# BILL OF MATERIALS - KIT

Accessory: All Weather Mat, Front Driver  Vehicle: ES350  Model: -  Year: 2007+

Part No.: PT908-3307F-02/-11/-14  Supplier: Thermoflex Corp.  Product wt.: 1.40 kg / 3.09 lb

PT908-3307F-XX

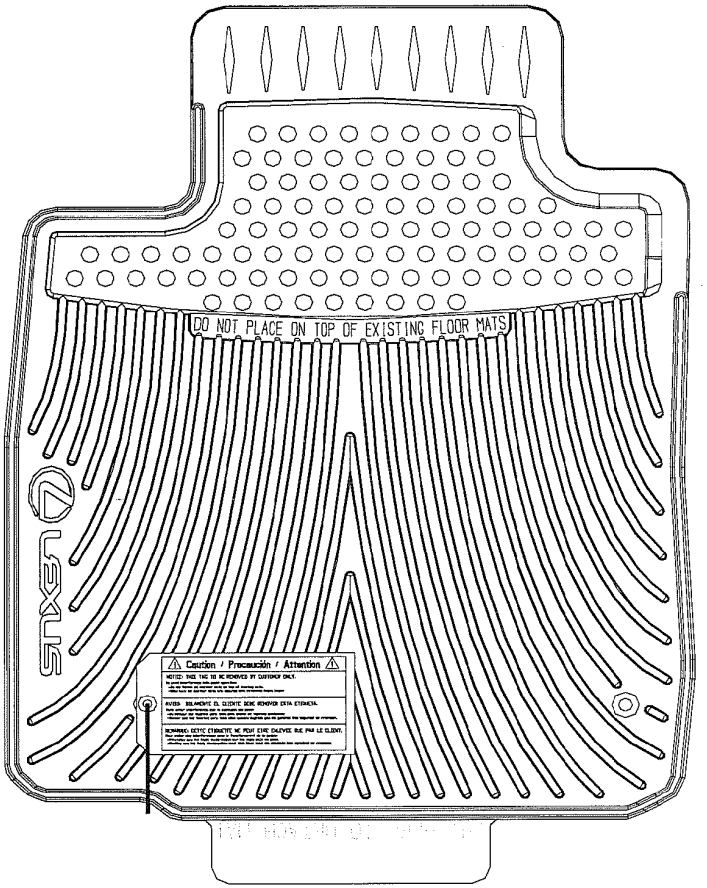
| Date | Revision Description | ECR # |
|---|---|---|
| 05/29/07 | Part number is PT908-33071; Warning text height/depth is 10mm x 1mm, was 4mm x 0.4mm | 07-060 |
| 05/29/07 | Add warning tag attached with zip tie | 07-089 |
| 10/15/07 | P/N is PT908-33072; Increased accel. clearance; modified edge and heelpad | 07-163 |
